Whine Noise From Rear of Vehicle

Service Category Drivetrain

Section Axle/Differential

YEAR(S)	MODEL(S)	ADDITIONAL INFORMATION
2016 - 2017	Tacoma	Body Type(s): D CAB

Figure 4.

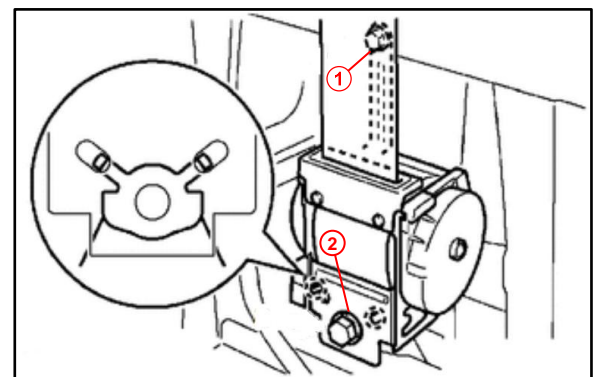
- F. Torque the seat belt bolts.

Bolt A

Torque: 12.5 N*m (127 kgf*cm, 9 ft*lbf)

Bolt B

Torque: 42 N*m (428 kgf*cm, 31 ft*lbf)

Figure 6.

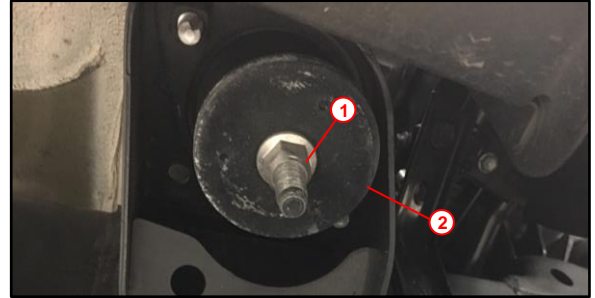
3. Install the frame dynamic damper.
 - A. Remove and discard the No. 3 nut cab mount (17 mm) and LH and RH cab mounting cushion stopper.

Figure 7.

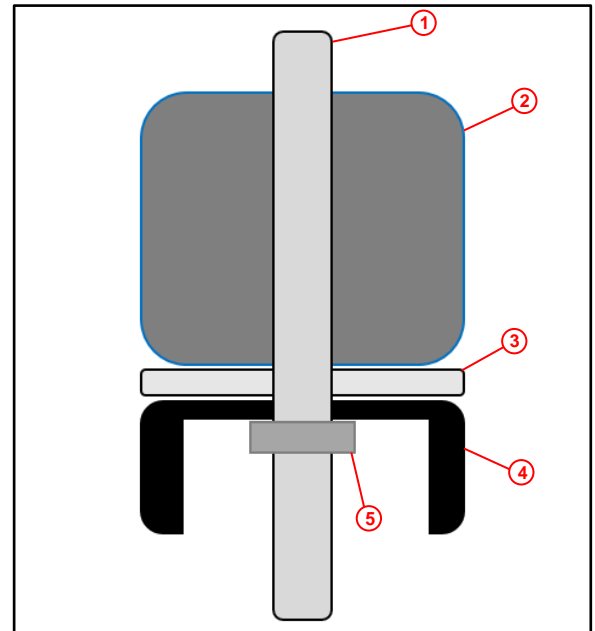
- B. Install the NEW cab mounting cushion stopper and the NEW frame dynamic damper to the RH and LH cab mount.
 - C. Retighten the cab mount nut.
Torque: 45 N*m (459 kgf*cm, 33 ft*lbf)
